ALERT SERVICE BULLETIN

REPLACEMENT OF FUEL PUMP

FOR ROTAX® ENGINE TYPE 912 (SERIES) SB-912-053

(see Fig.1)

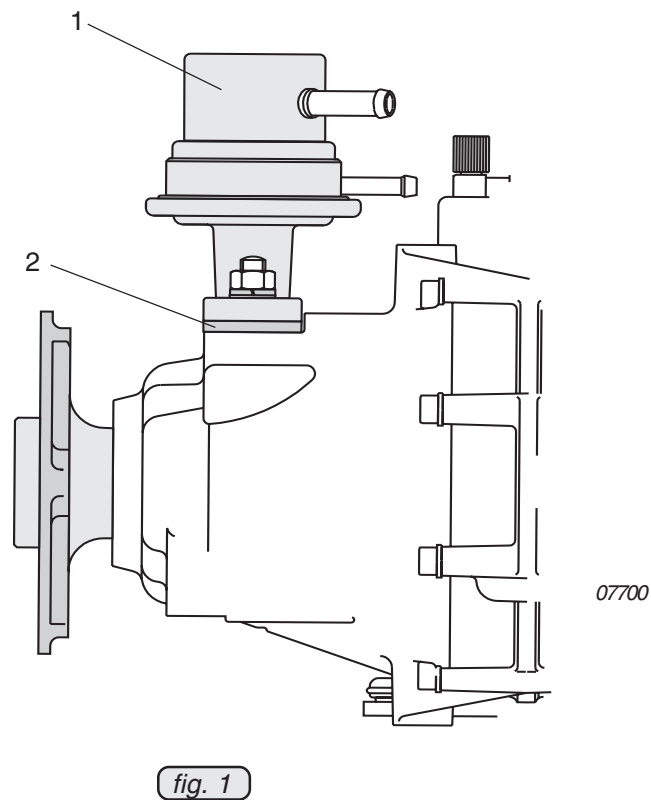
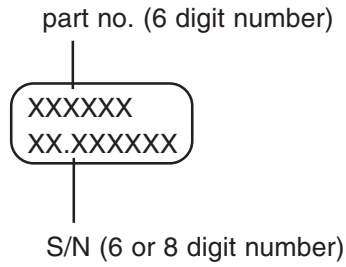
Due to high fuel pressure, caused by exceeding pressure in front of the mechanical fuel pump (e.g. due to an electrical fuel pump), in limited cases a deviation in the fuel supply could occur. This can result in exceeding of the fuel pressure and might cause engine malfunction and/or massive fuel leakage.

Replacement of fuel pumps with part no. 892230, 892232, 892540 through part no. 892542 and Replacement of fuel pumps with part no. 892235, 892236, 892545 through part no. 892546 for ROTAX® engine type 912 (Series).

1. Remove fuel pump (1).
2. Gasket (2) replaced by new part.

■ **CAUTION:** Install new gasket supplied with new fuel pump. The thickness is different.

3. Install fuel pump. Tightening torque 15 Nm (133 in.lb).
4. Install fuel line.
